Permit Amendment

T-14254

In the Matter of Permit Amendment)	FINAL ORDER
T-14254, Benton County)	DENYING A CHANGE IN POINT OF
)	APPROPRIATION

Ground Water Review Form:

Permit Amendment Application Map

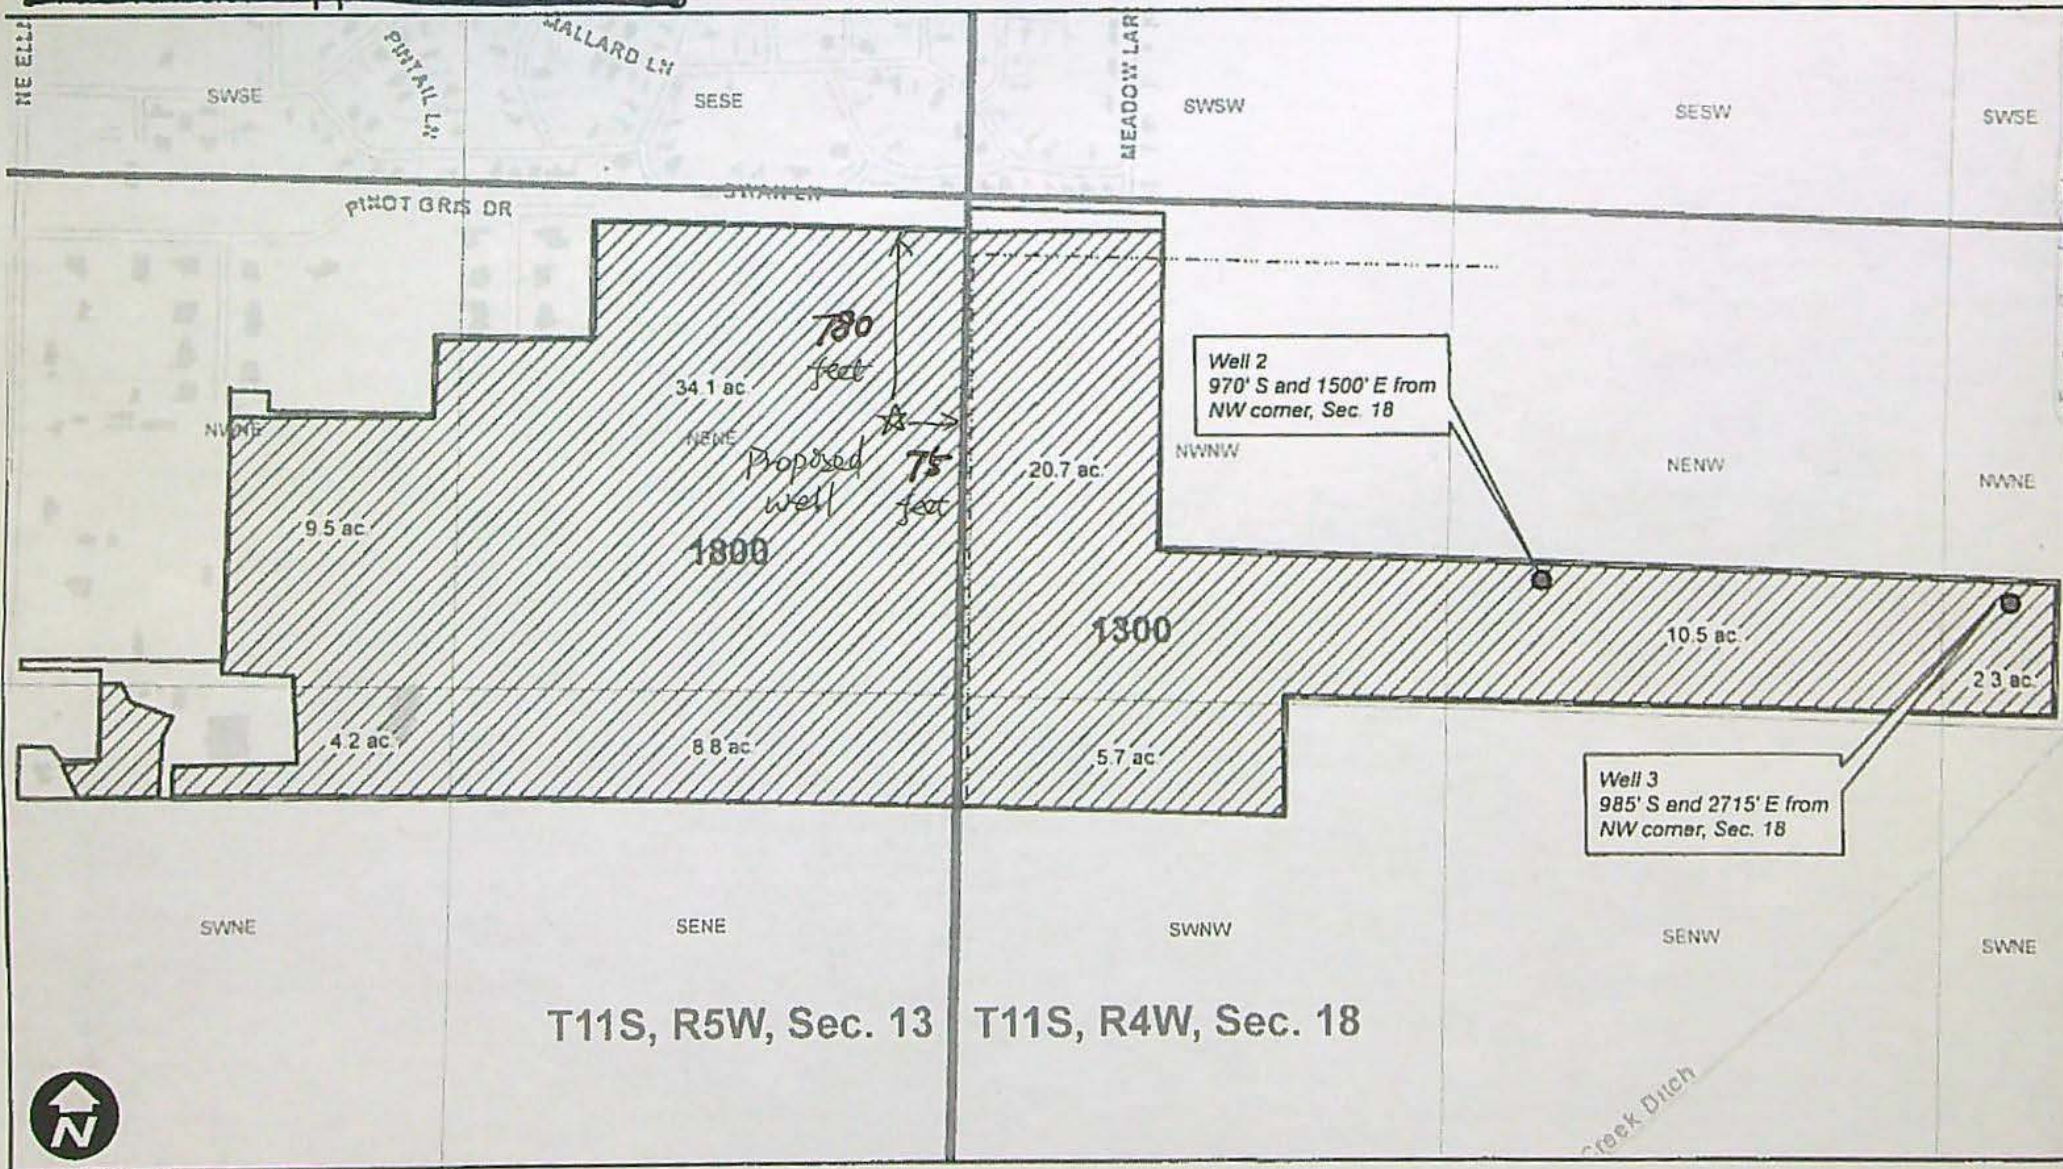
6. The application proposes to change the point of appropriation for a portion of Permit G-18601, specifically 62.41 acres. The applicant did not include any information in the application or on the application map to indicate which lands (the FROM lands) currently authorized under Permit G-18601 will be served by the new proposed well (POA 3), therefore the application is incomplete.

9. The change does not enlarge the permit.
10. The change does not alter any other terms of the permit.
11. The application is incomplete because the applicant did not include any information in the application or on the application map to indicate which lands (the FROM lands) currently authorized under Permit G-18601 will be served by the new proposed well (POD 3). Therefore, all other application requirements are not met.
